STAFF RECOMMENDATION
913 Lawrence Avenue
July 19, 2017

Application: New construction—infill and outbuilding/detached accessory dwelling unit
District: Waverly-Belmont Neighborhood Conservation Zoning Overlay
Council District: 07
Map and Parcel Number: 10513031000
Applicant: John Root, rootARCH
Project Lead: Melissa Baldock, melissa.baldock@nashville.gov

Description of Project: Application is to construct infill and a detached accessory dwelling unit (DADU).

SITE PLAN

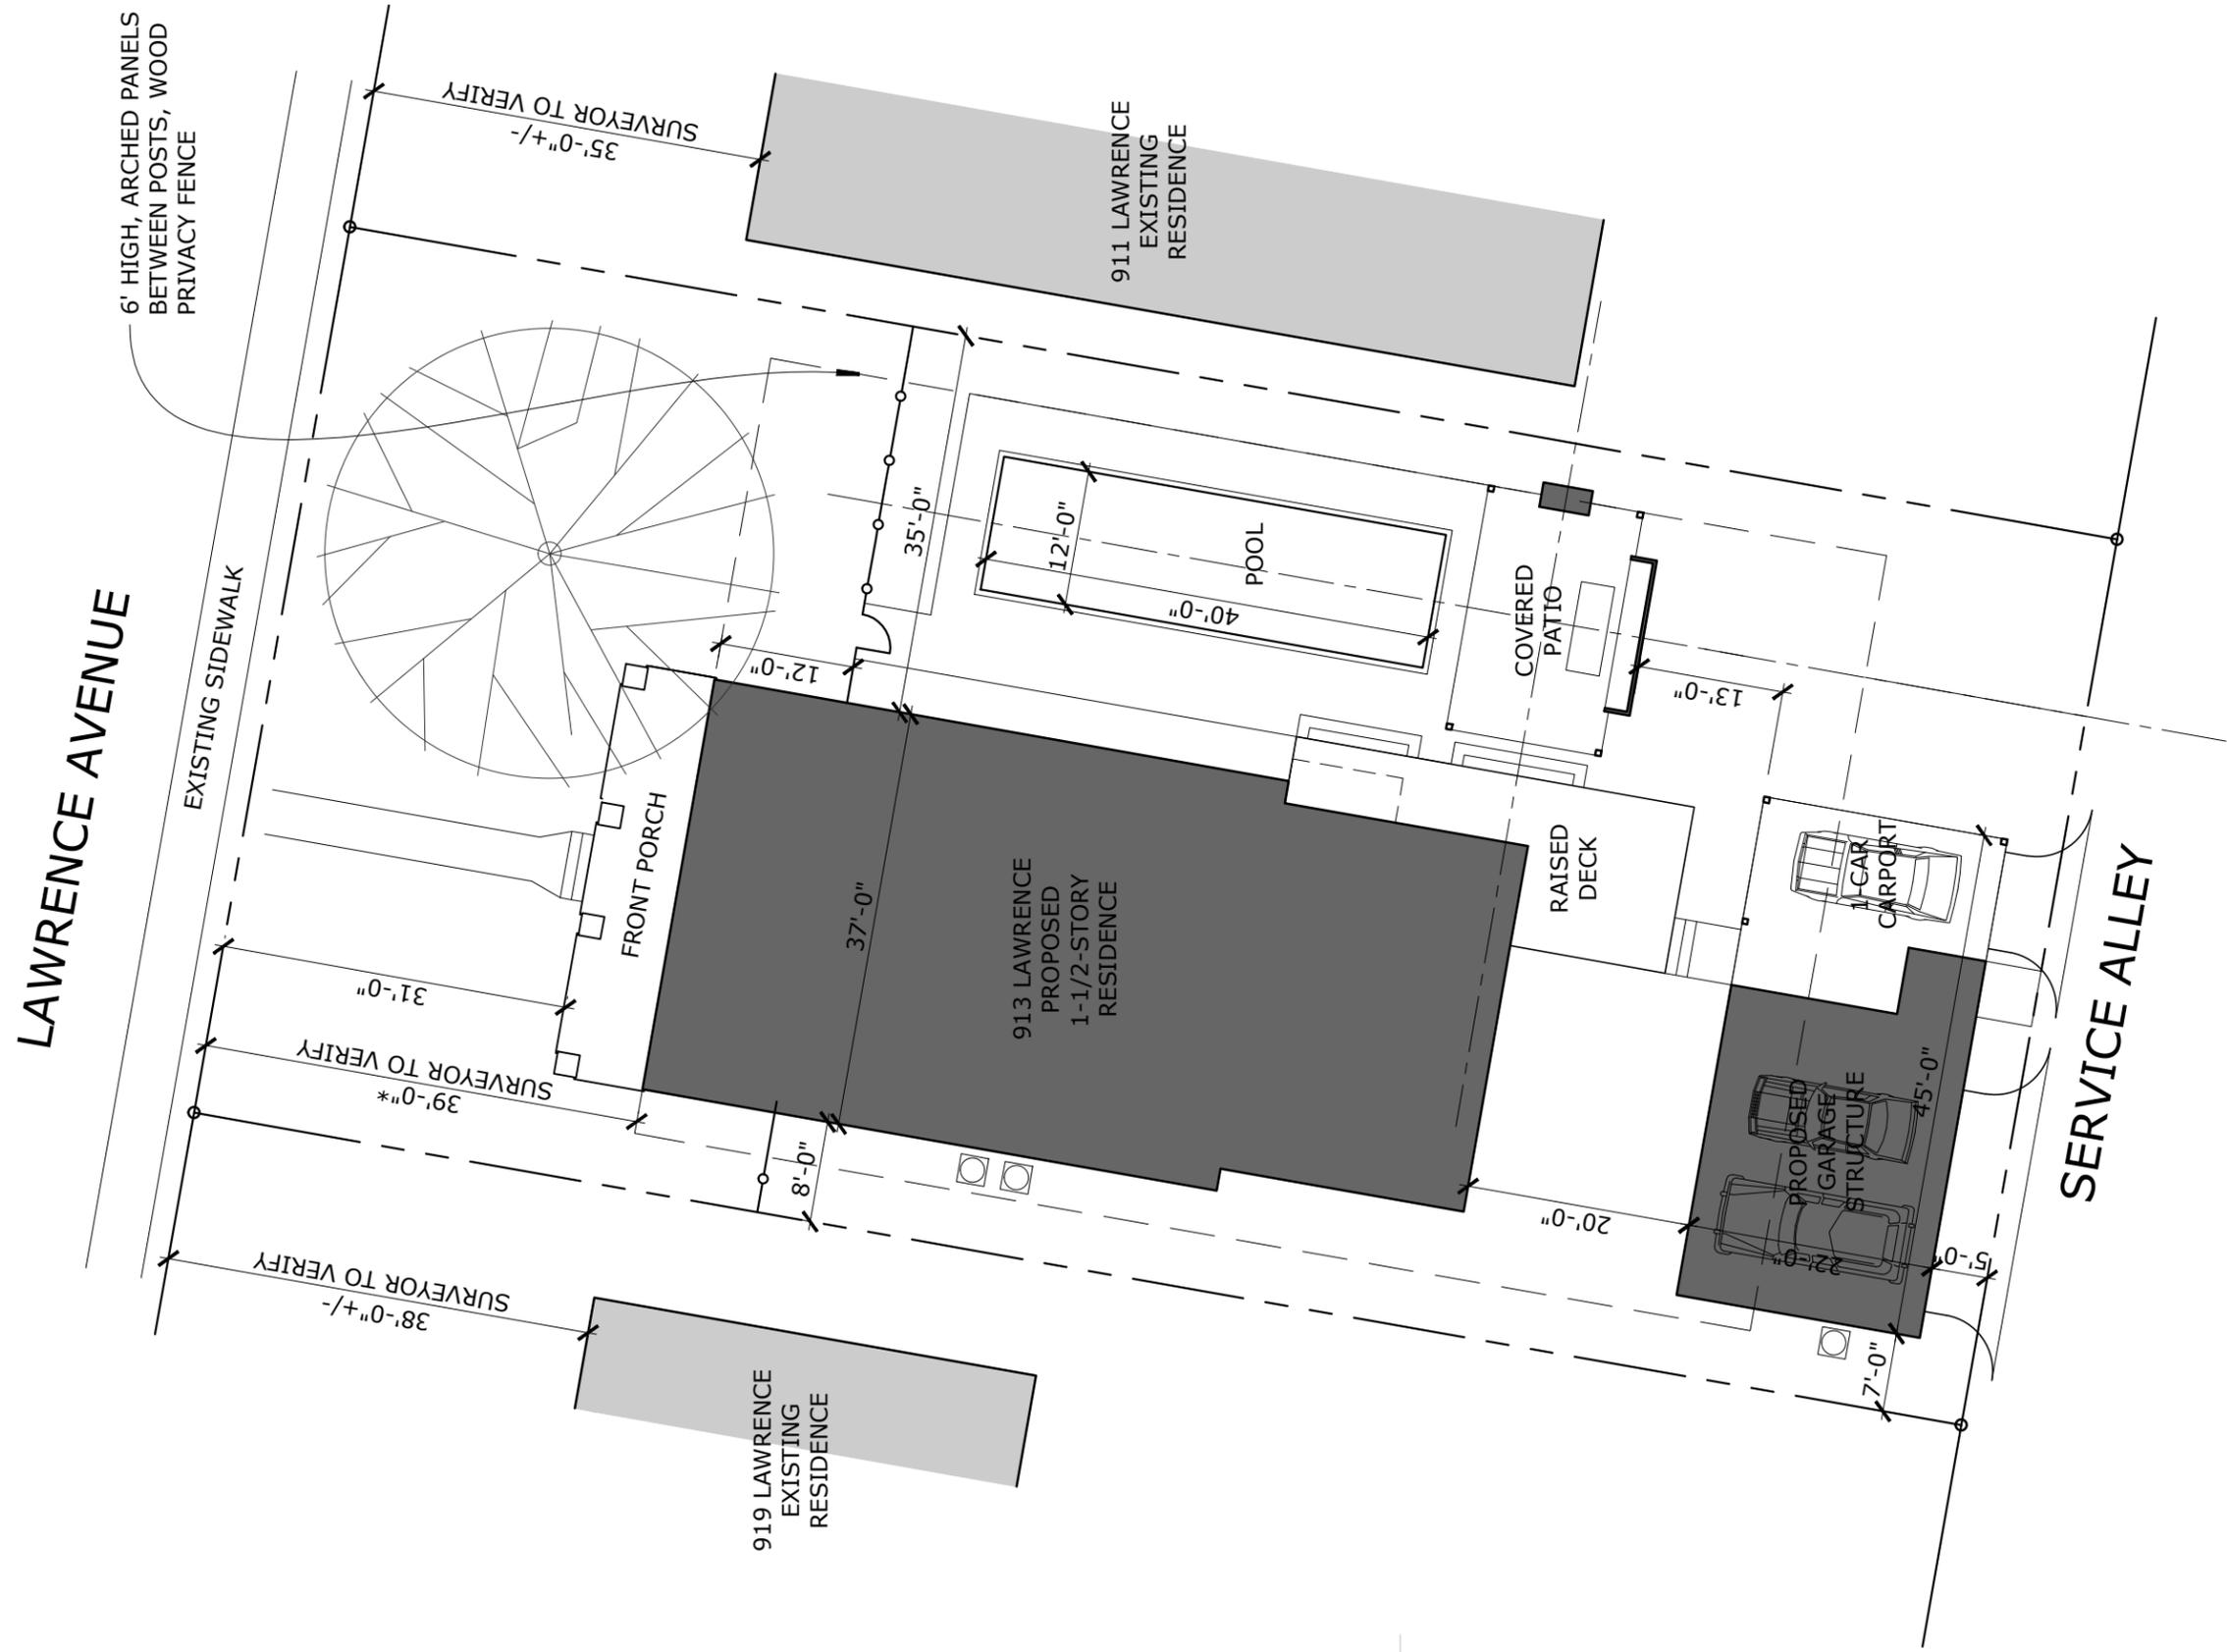
Setback & Rhythm of Spacing: The proposed infill meets all base zoning setback. It will be eight feet (8') from the right side property line, thirty-five feet (35') from the left side property line, and forty-seven feet (47') from the rear property line. The house is not centered on the wide lot. Staff finds this to be appropriate because the previous house on the lot was not centered on the lot, and other houses on wide lots in the immediate vicinity are not centered on the lot. Staff therefore finds that the house's placement on the lot will not affect the rhythm of spacing along the street.

The house's porch will be thirty-one feet (31') from the front property line and the house's wall will be thirty-nine (39') from the front property line. The front wall of the house will line up with the front wall of the house next door and 919 Lawrence. Staff finds this to be appropriate since the infill is shifted on the lot so that it closer to 919 Lawrence than it is to 911 Lawrence.

Minimum	Proposed
DADU rear setback	5’	5’
DADU left side setback	5’	28’
DADU right side setback	5’	7’
Distance between DADU and House	20’	20’
Covered Patio rear setback	3’	40’
Covered Patio left side setback	3’	5’
Covered Patio right side setback	3’	53’
Distance between Covered Patio and House	20’	9’*

*The design guidelines state that there should be a minimum of twenty feet (20’) in between a primary structure and an outbuilding. This guideline presumes that the outbuilding will be located behind, not to the side of the primary structure. Staff finds that if the footprint of the covered patio is reduced to be no more than two hundred square feet (200 sq. ft.), then the distance of nine feet (9’) is appropriate because the size of the outbuilding is so modest and because the covered patio will be located so far back from the front of the house.

FRONT ELEVATION

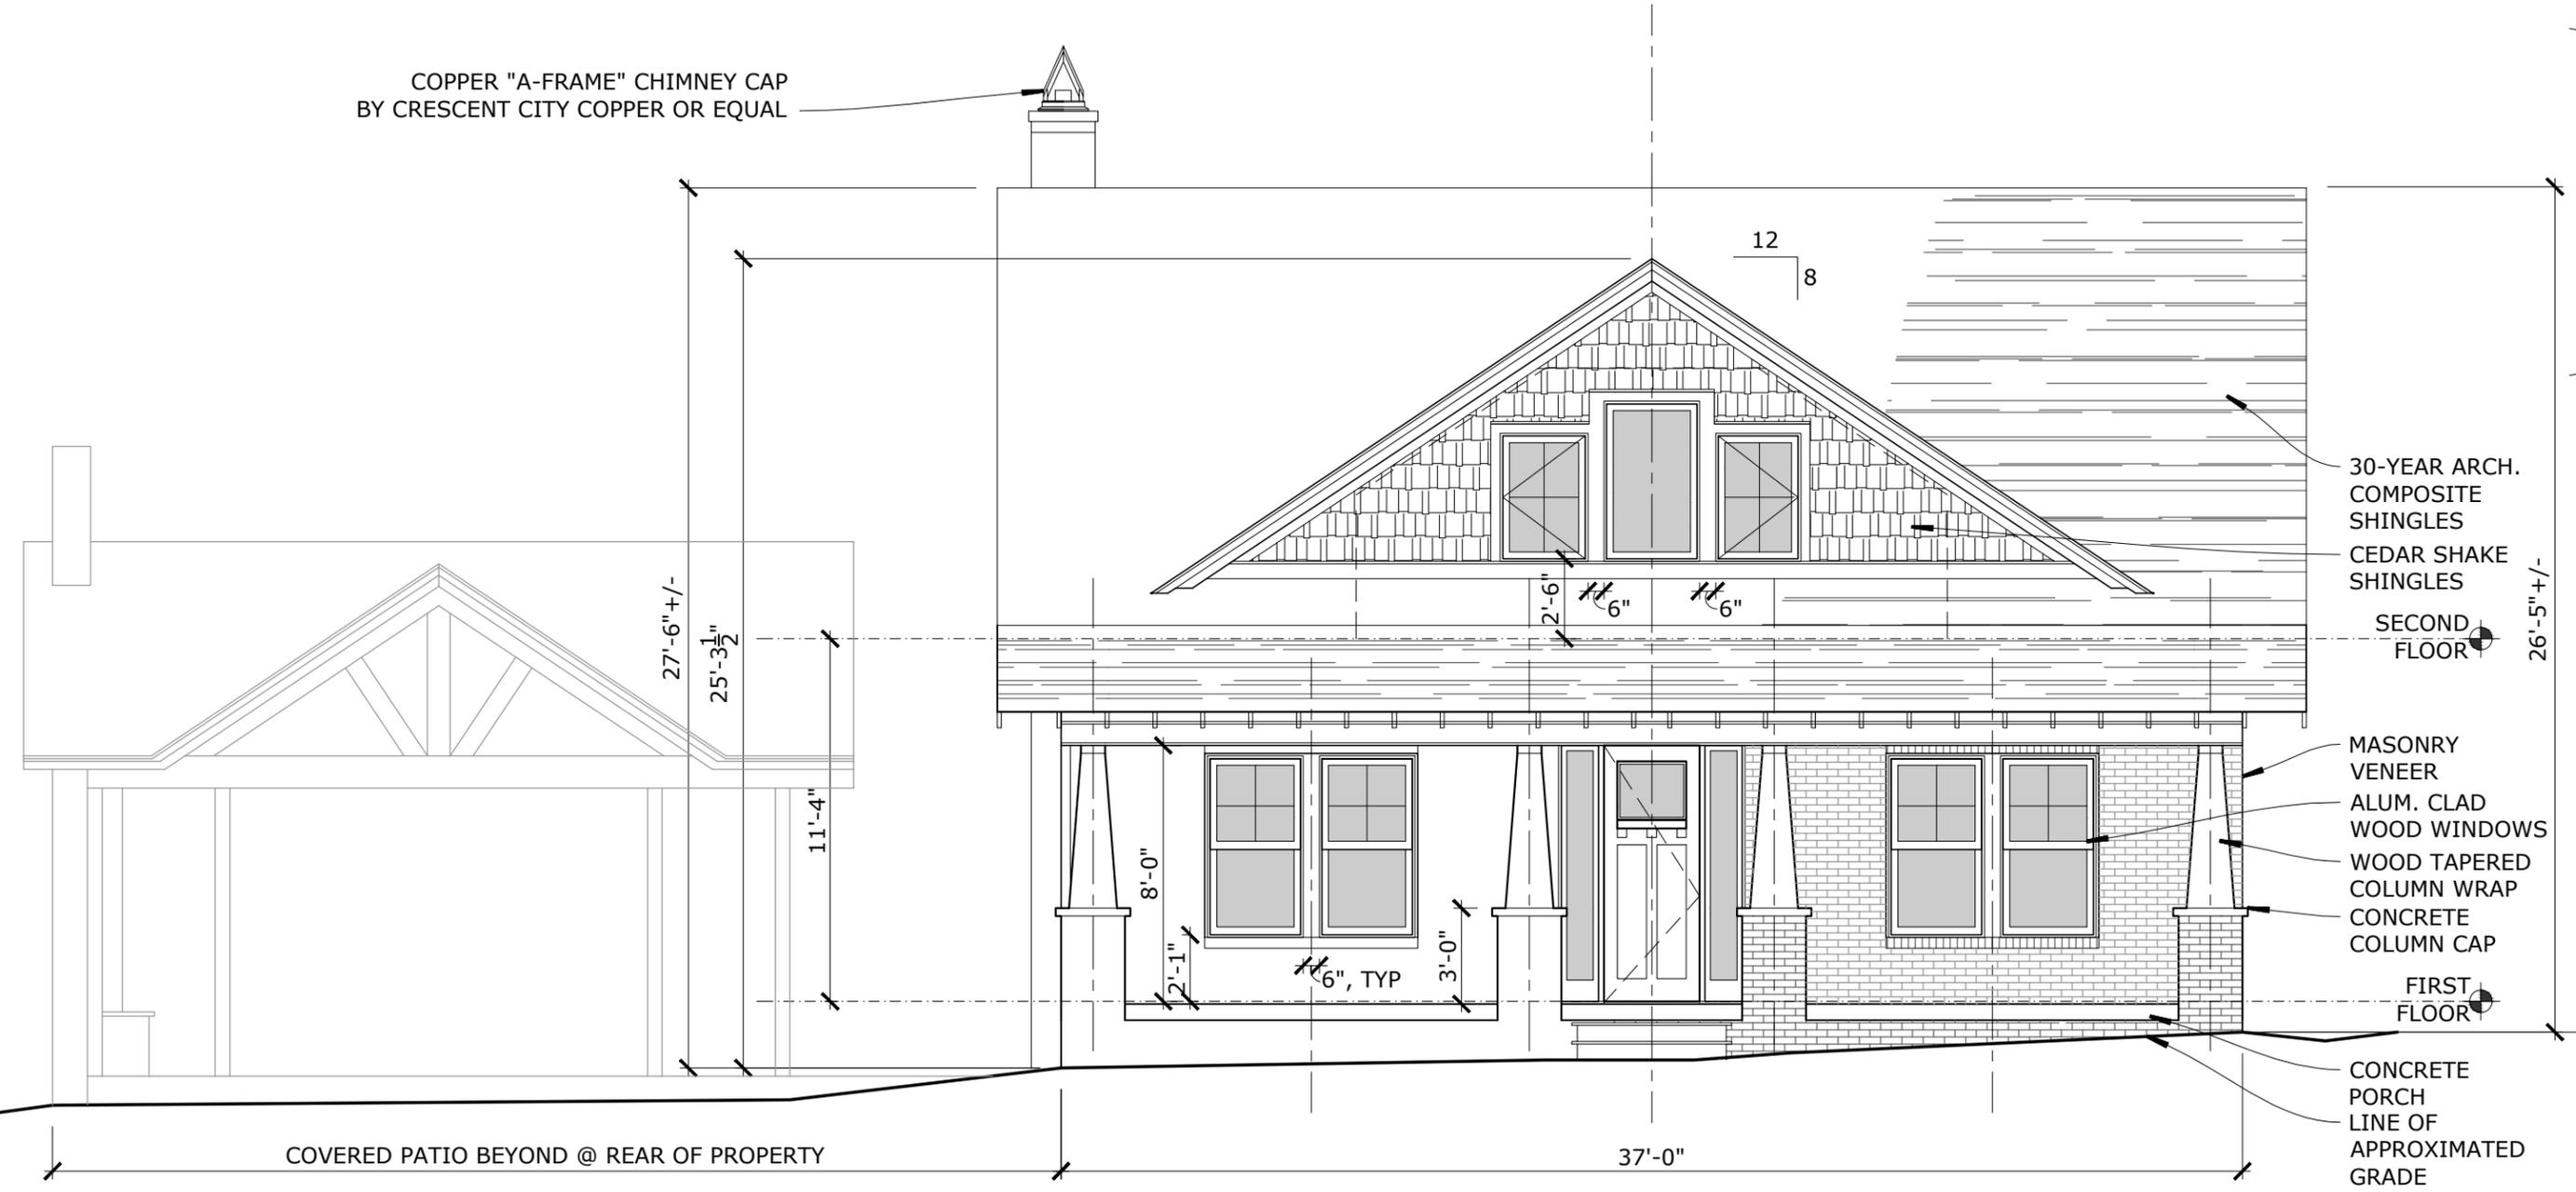
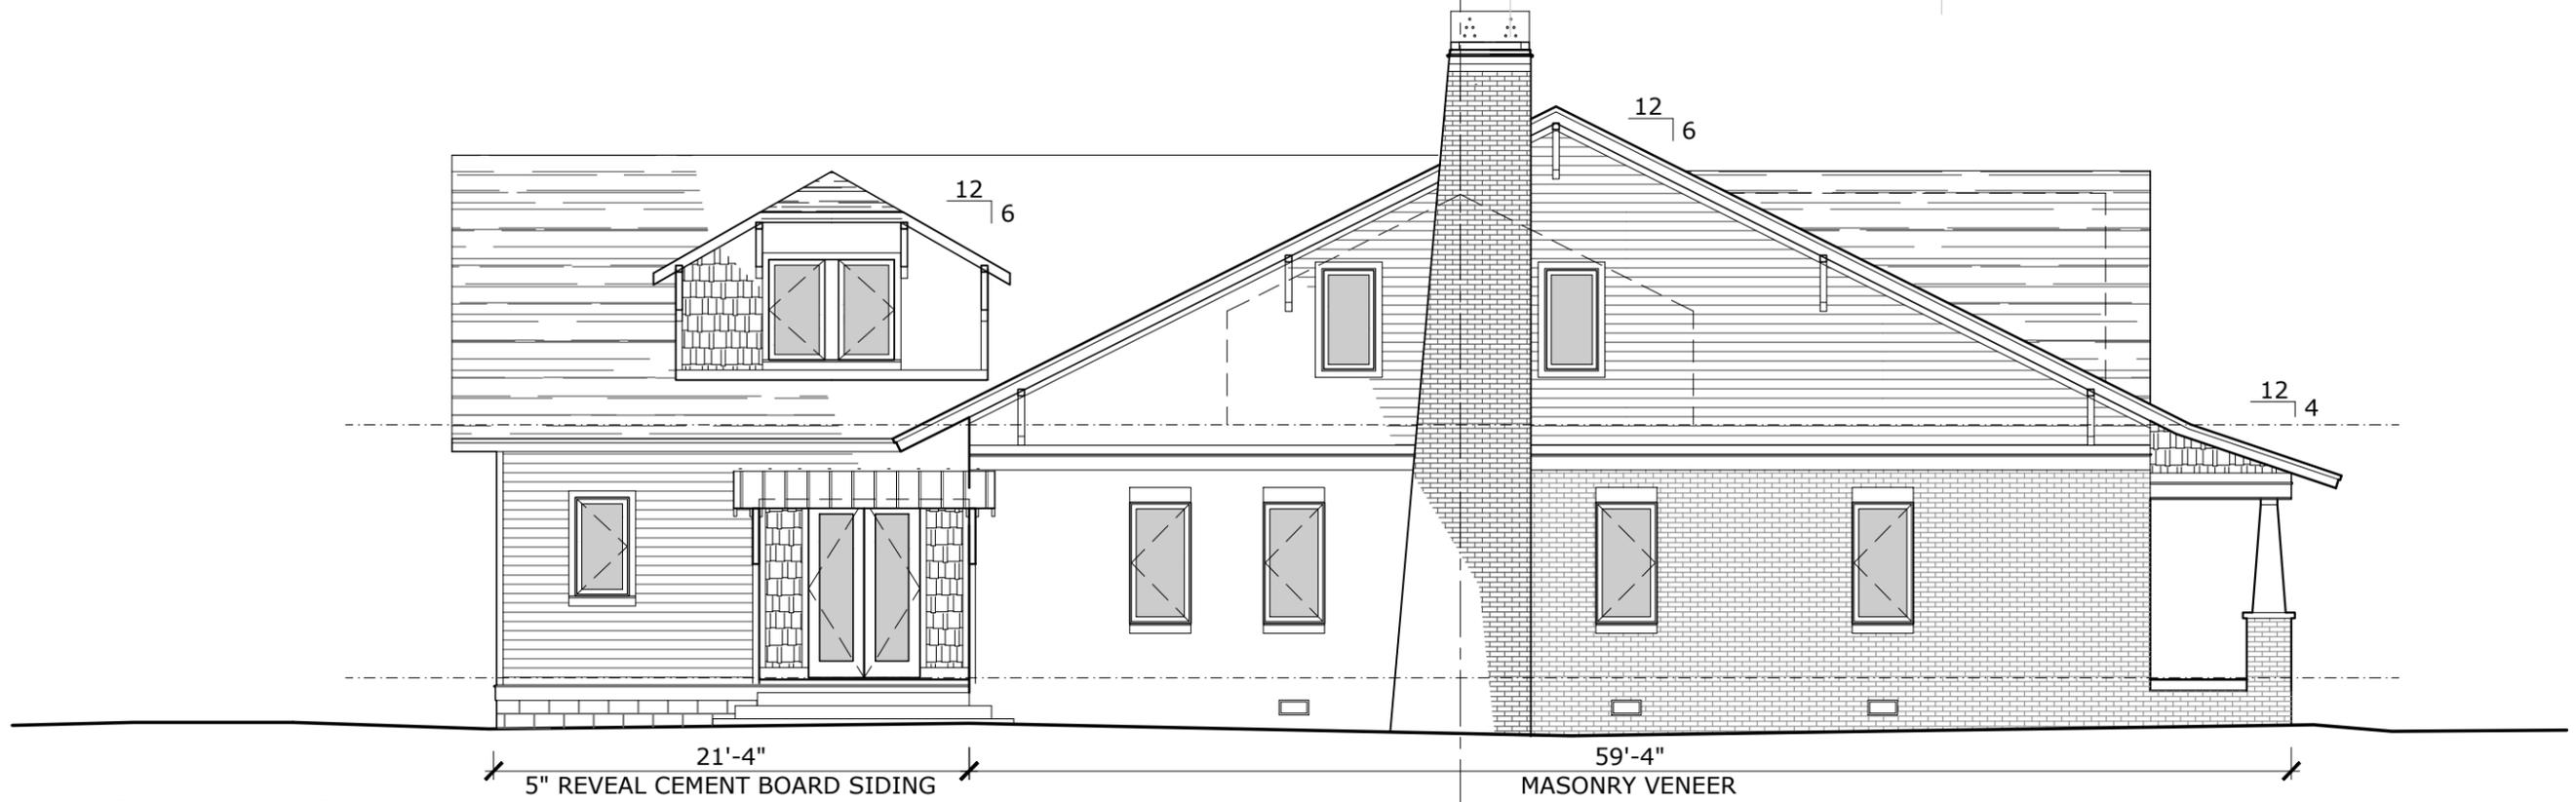
Height & Scale: The proposed house is one-and-a-half stories, with a maximum height of twenty-seven feet, six inches (27'6") from grade. Staff finds that this meets the historic context, where the houses are largely one and one-and-a-half stories with maximum heights ranging from nineteen feet to thirty feet (19'-30'). The foundation height will range from one to two feet (1'-2'), and the eave height will range from ten to eleven feet (10'-11') from grade.

*The drawings do not show a change in material from the foundation line to the wall above. The design guidelines state, “Foundation lines should be visually distinct from the predominant exterior wall material. This is typically accomplished with a change in material.” Staff recommends that foundation material be different than the brick wall of the infill. Appropriate foundation materials could be stone, stucco, or split face concrete block.

Staff recommends that the lap siding be smooth with a maximum reveal of five inches (5”). Staff recommends approval of a brick sample, all windows and doors, the metal and shingle roof colors and materials, and the material of the side porch steps and landing. With the aforementioned conditions and staff approval of materials, staff finds that the known materials meet Section III.D. of the design guidelines.

Roof form: The primary roof form is a side gable with a cross gable element on the front façade. The side gable will have a slope of 6/12, and the front cross gable will have a slope of 8/12. The rear section of the house will have side dormers that have hipped

1. The finished floor height be consistent with the finished floor heights of the adjacent historic houses, to be verified by MHZC staff in the field;
2. There be a change in material at the foundation line to delineate the foundation from the wall above;
3. The lap siding be smooth with a maximum reveal of five inches (5”);
4. Staff approve a brick sample;
5. Staff approve all windows and doors;
6. Staff approve the metal and shingle roof color and texture;
7. Staff approve the material of the side porch floor and steps;
8. The covered patio accessory structure have a footprint no larger than two hundred square feet (200 sq. ft.); and
9. Staff receive a filed copy of the restrictive covenant for the DADU.
